1962 Corvette: Service Bulletin: Aluminum Powerglide Shift Problems

Subject: Aluminum Powerglide Shift Problems

Bulletin No: DR #514

Date: January 16, 1962

FIGURE 1- 327 AND 283 POWERGLIDE TV LINKAGE COMPARISON

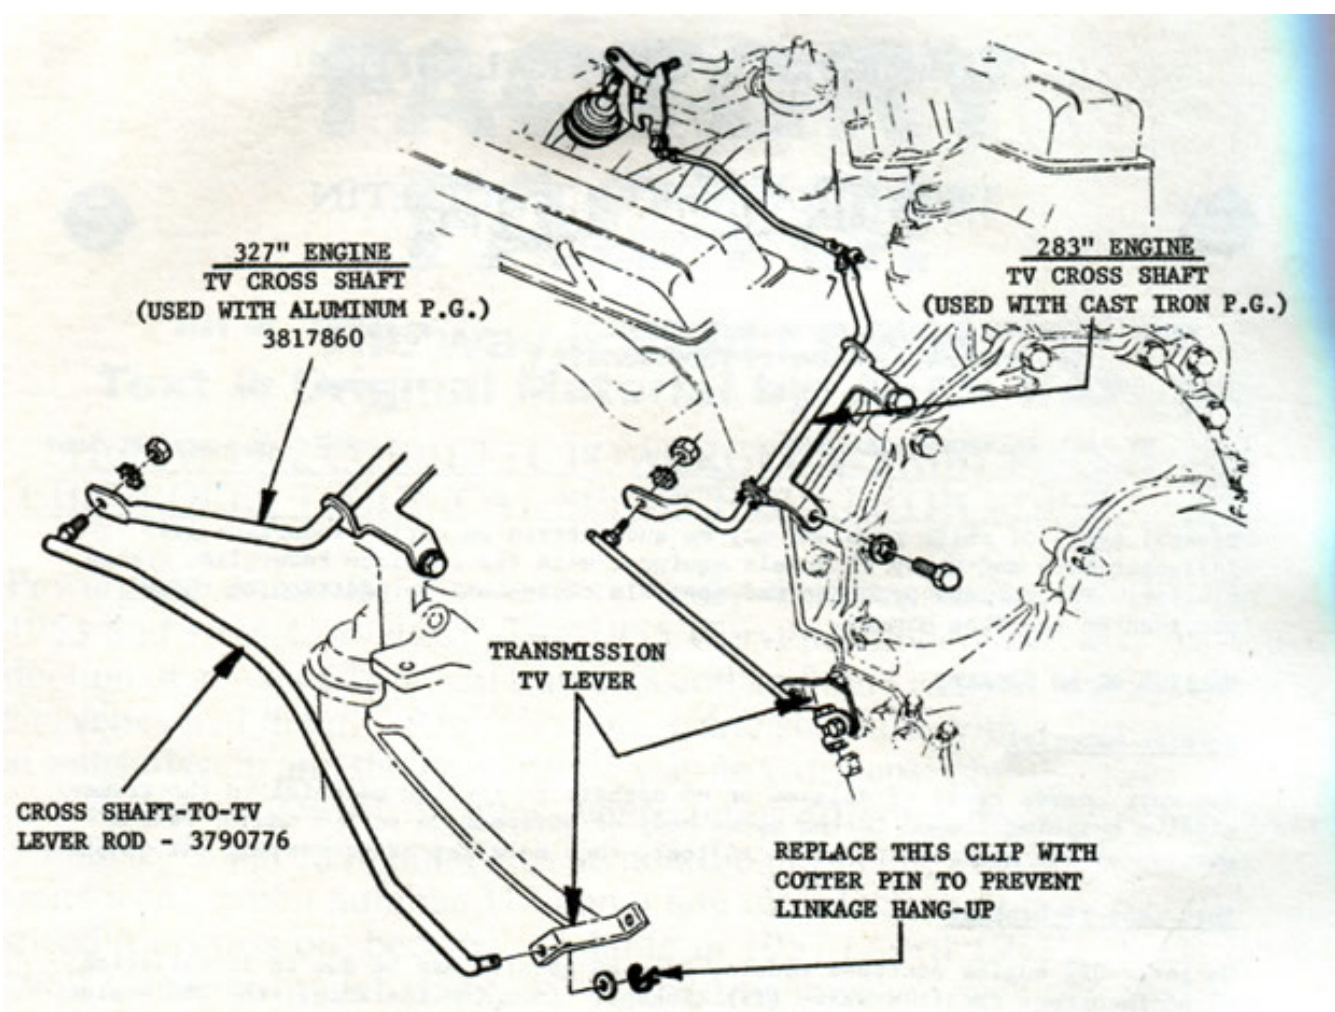
Incorrect TV Linkage

On early 327 engine equipped models, delayed upshift may be due to installation of an incorrect throttle valve (TV) linkage. In a few instances, the 283 engine cross shaft was installed instead of the correct TV cross shaft, 3817860. The TV cross shaft are easily identified as the 283 version has a bend in its outboard lever whereas the 327 cross-shaft lever is straight in this same area. (Figure 1). If the TV cross shaft was incorrect, also check the cross shaft-to-TV lever rod. As shown in Figure 1, this rod, 3790776, is formed on 327 engine applications as compared to the straight rod used on 283 engine versions.

Cross Shaft, TV (327 engine) ---- 3817860

Rod, Cross Shaft-to TV (327 engine) ----- 3790776

FIGURE 2 - ALUMINUM POWERGLIDE DIPSTICKS

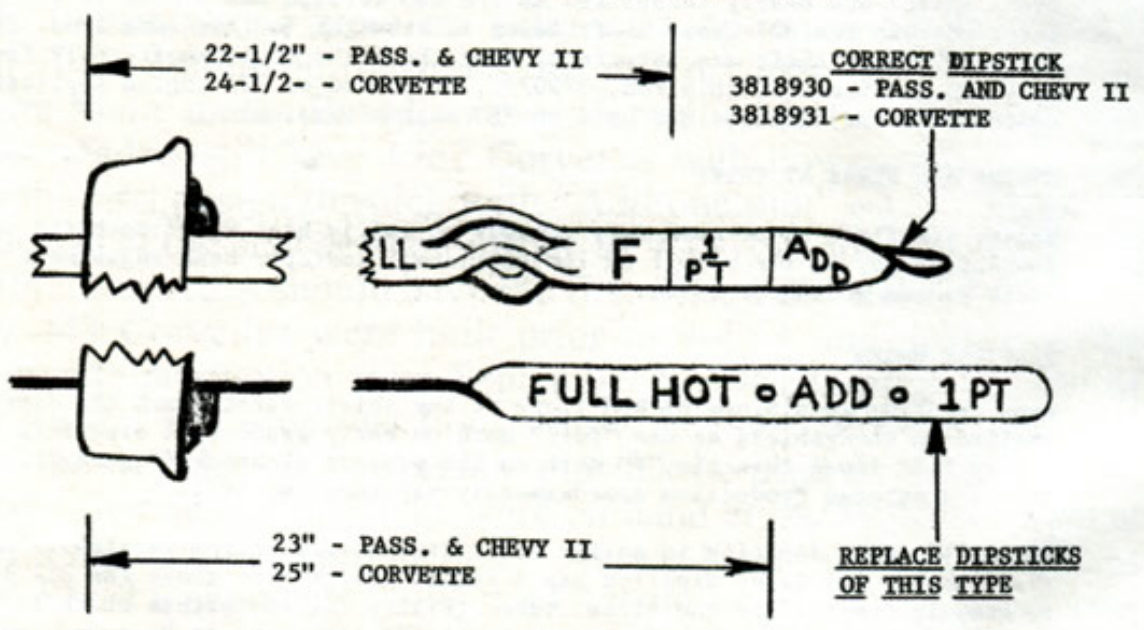
Dipstick Usage

When checking complaints of RPM flare at the shift, first check the dipstick installed in the vehicle as the "Full" mark on early production dipsticks is approximately 1/2" lower than the "F" mark on the present dipstick (Figure 2). The later dipstick entered Production approximately September 4, 1961.

The early style dipstick is easily identified as its bottom section is absolutely flat whereas the later dipstick has a formed bridge just above the oil level markings to keep it centered in the filler tube. (Figure 2). A further check is to measure the distance from the top of the cap to the "Full" mark; on

Passenger and Chevy II dipsticks, this distance is now 22-1/2", as compared to 23" on the earlier dipsticks. This distance on the Corvette dipstick is now 24-1/2" as compared to 25" on earlier units.

Replace all early dipsticks with the later part when found and add oil as

required to raise the transmission oil level to the "F" mark. The later dipstick for 327 engine passenger cars and all Chevy II Models is 3818930; for Corvette, 3818931.
